SUBJECT: ADDENDUM No. 1

FILE: FHWTP Flocculation and Sedimentation Basins 1 & 8 Equipment Upgrade WT7093

**FLEMING HILL WATER TREATMENT PLANT FLOCCULATION AND
 SEDIMENTATION BASINS 1 & 8 EQUIPMENT UPGRADE PROJECT – WT7093**

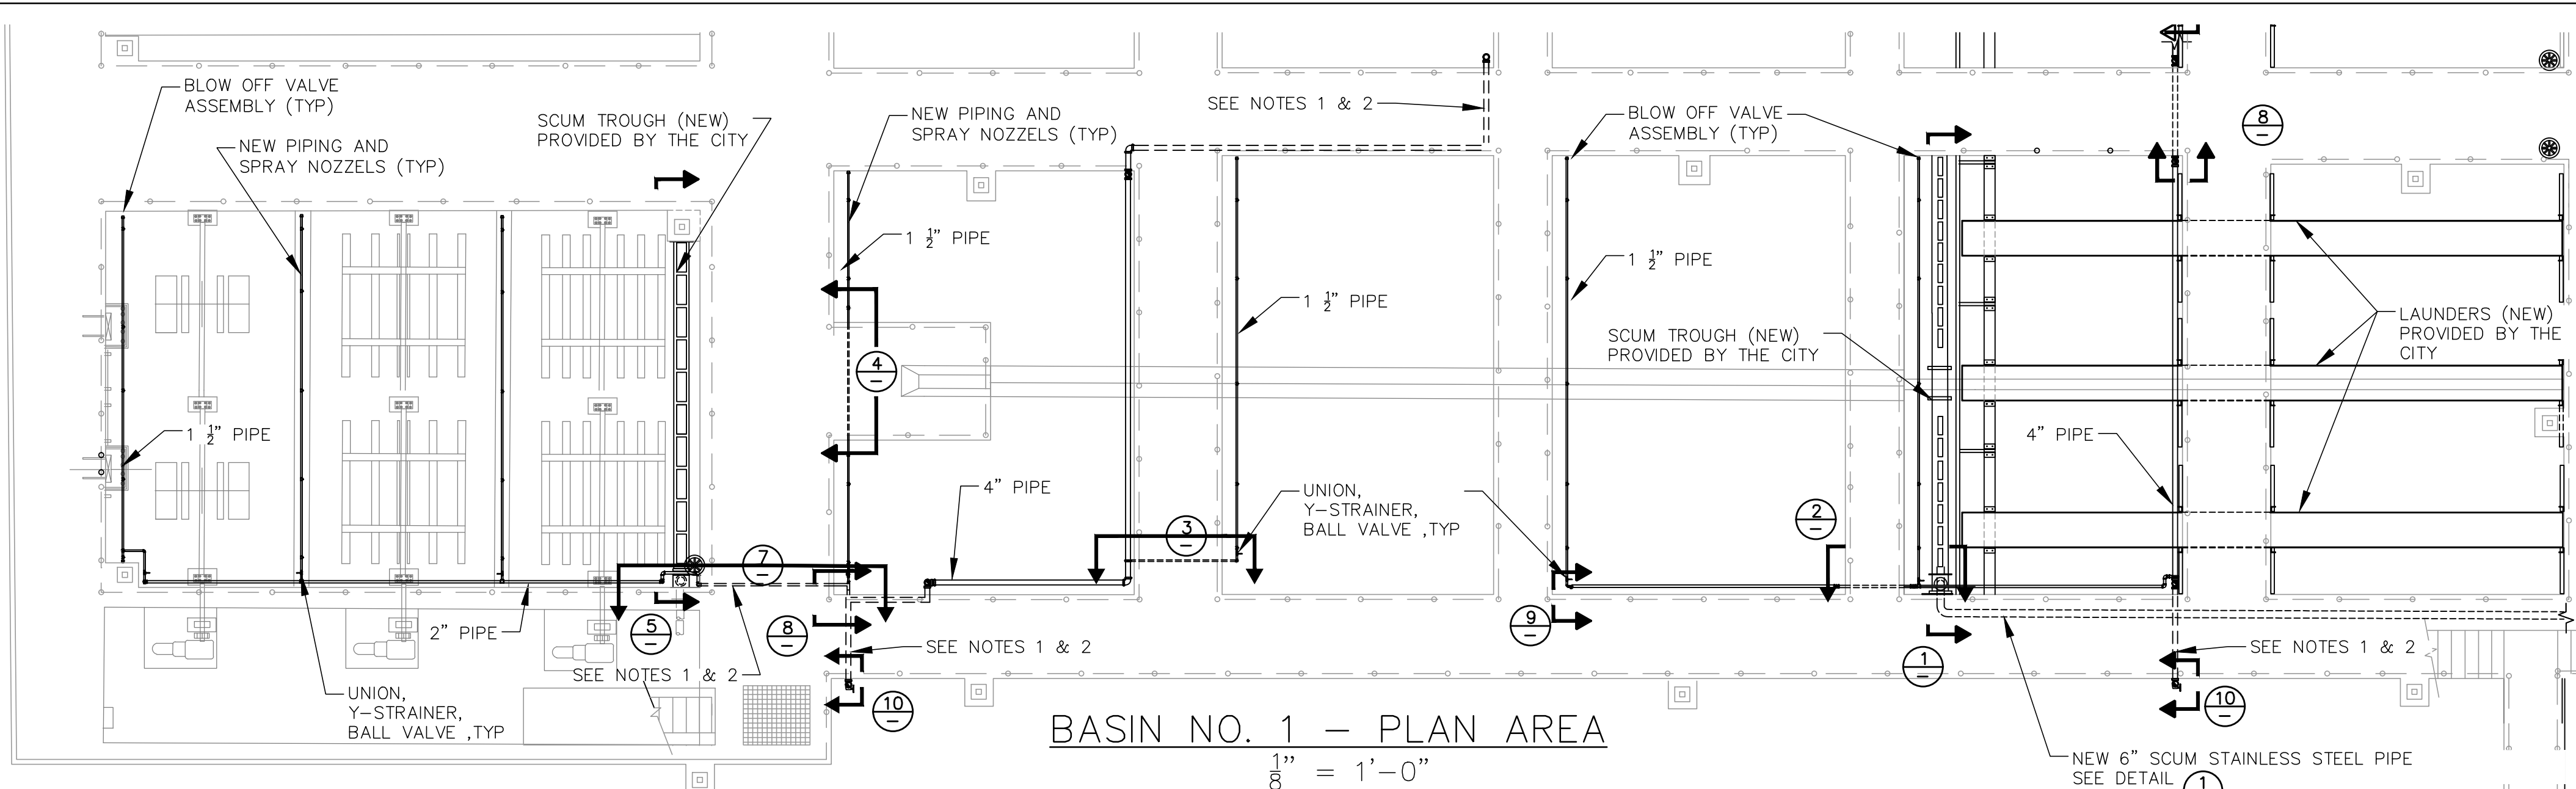
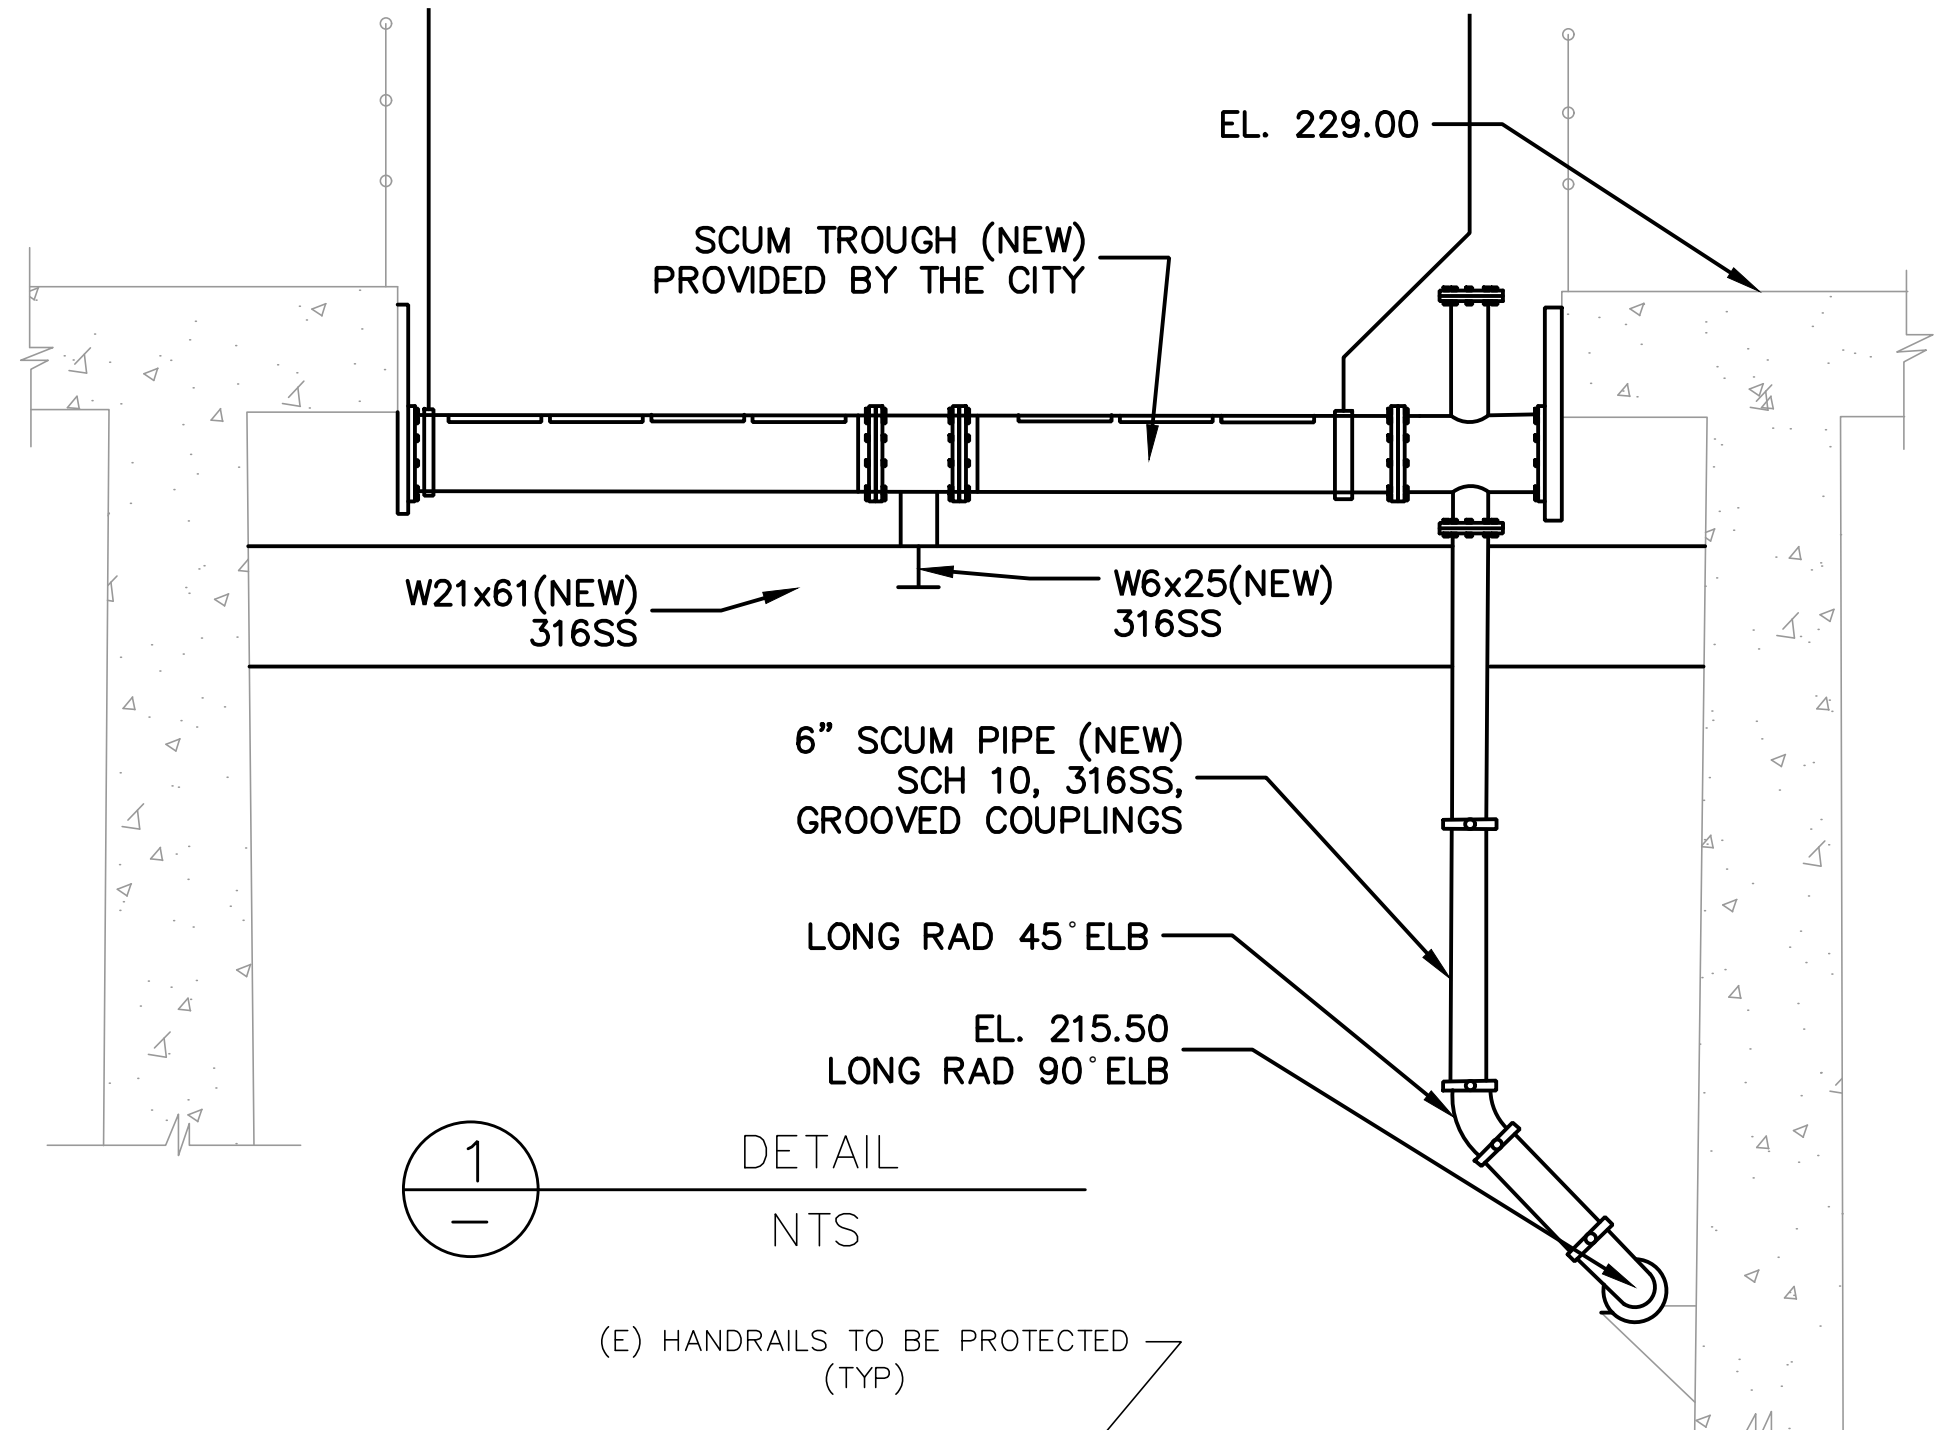
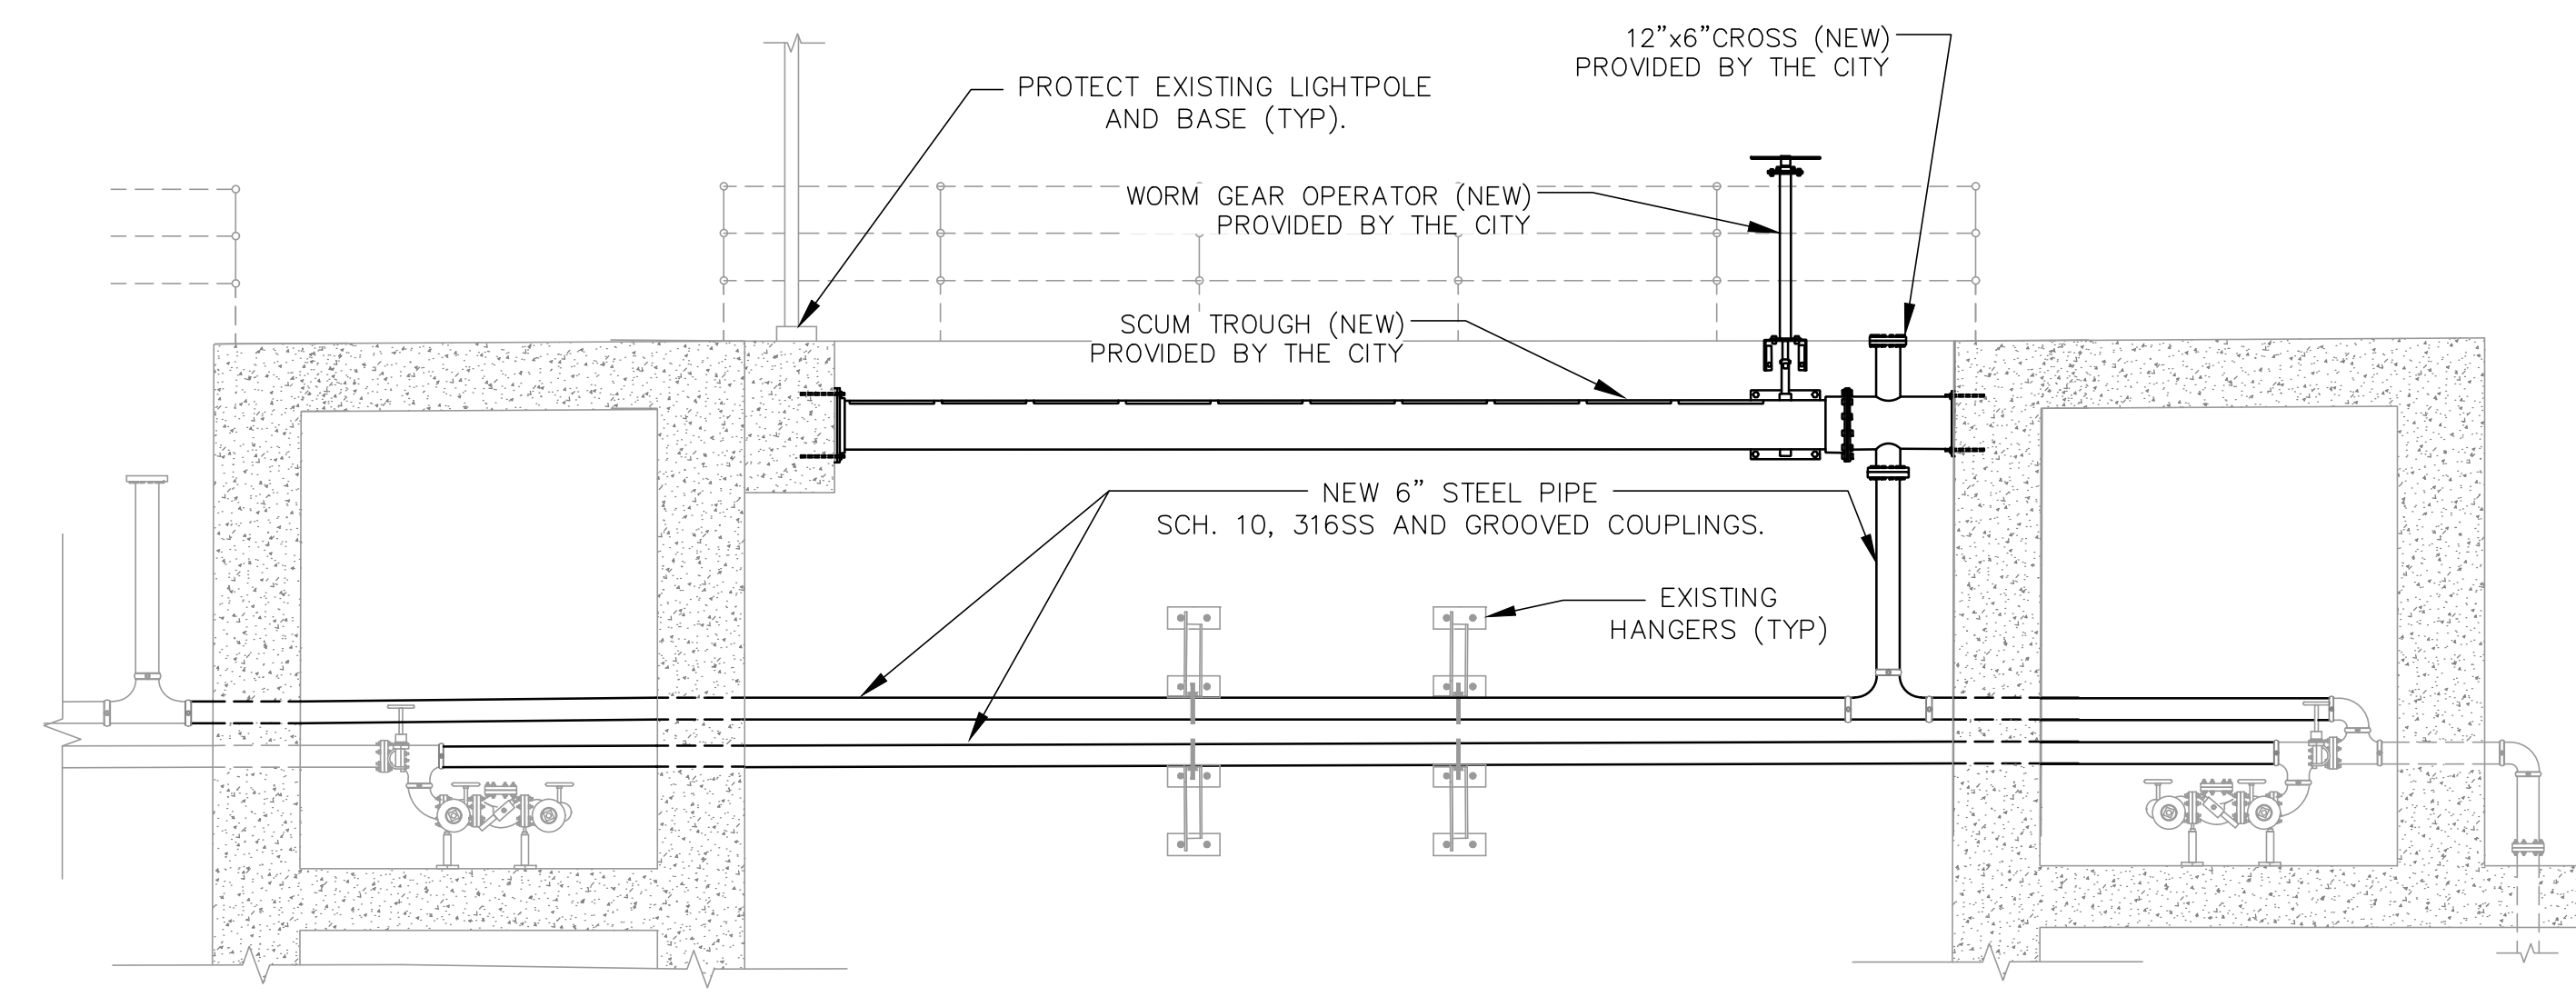
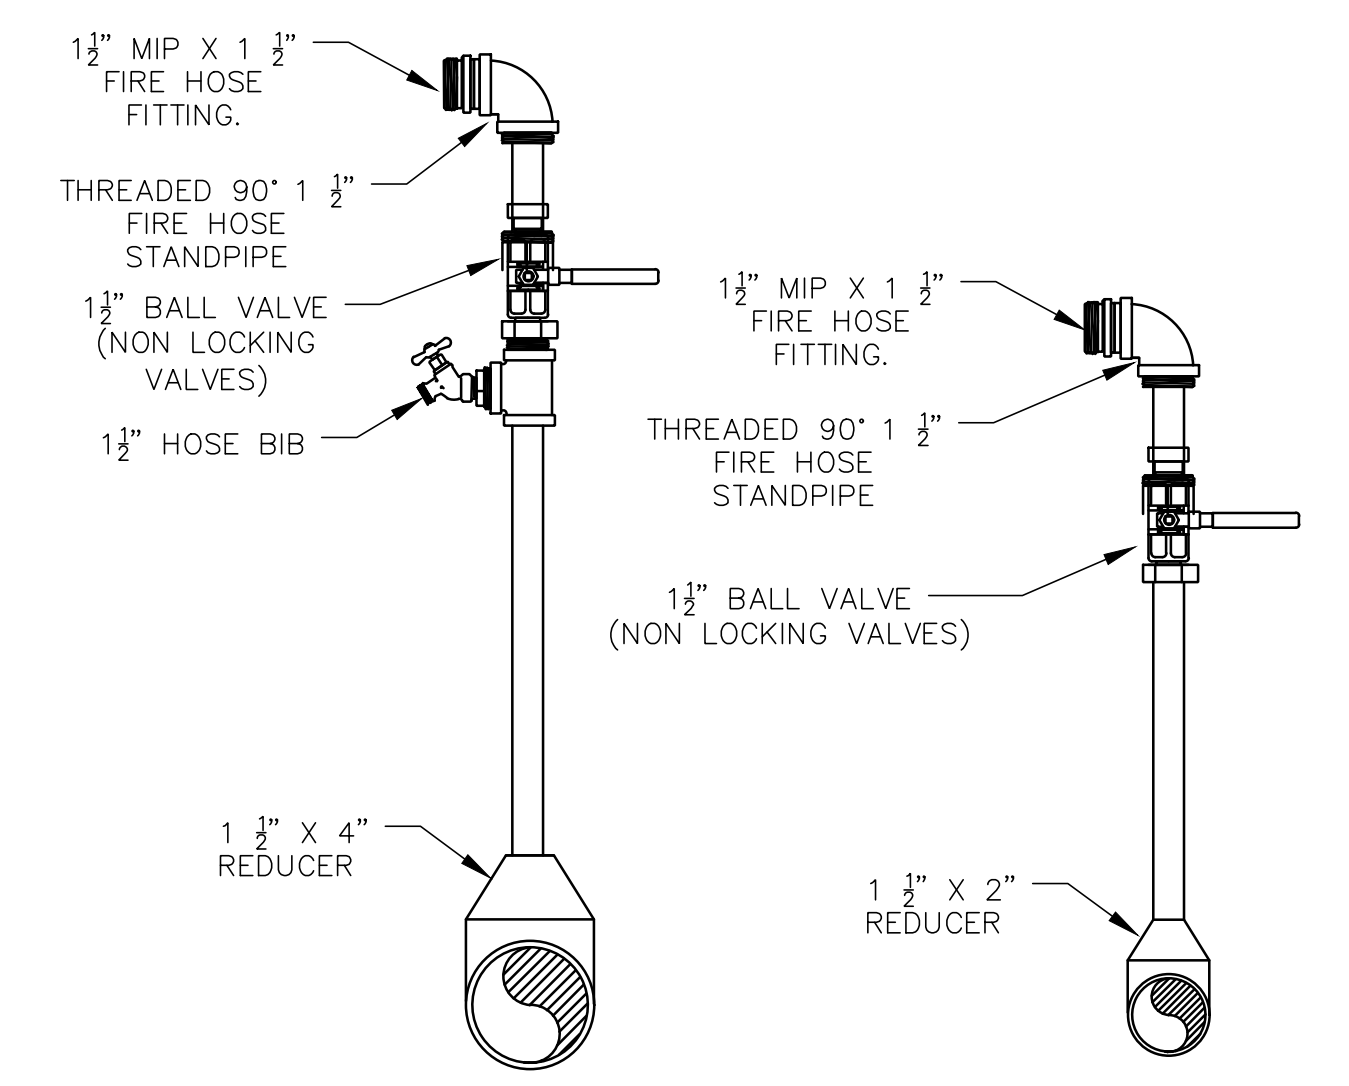
Sheets 21: Added notes. Combined and modified Details 5 and 6.

14) Question: Sheet 21. We are to provide new spray nozzles, blow off assembly, and wye strainers, but have not found a specification for anything other than the ball valves. In addition, it is not clear what the layout (spacing) or quantities will be required.

Response: Spray nozzles shall be 1/4" with a 128 degree spray angle (flat spray) at 20psig or equal. Five (5) sprayers will be required per spray piping run for a total of thirty five (35) sprayers (Basin 1 only).

Wye Strainers shall match pipe size, stainless steel 316 with 1/32-inch perforation per spray piping run (Basin 1 only).

Blow off assemblies at the end of spray piping runs shall be as follows:

Ball Valve with a 90 degree bend per spray piping run for sedimentation basin (Basin 1 only).

Ball Valve with two 90 degree bends per spray piping run for flocculation basin (Basin 1 only).
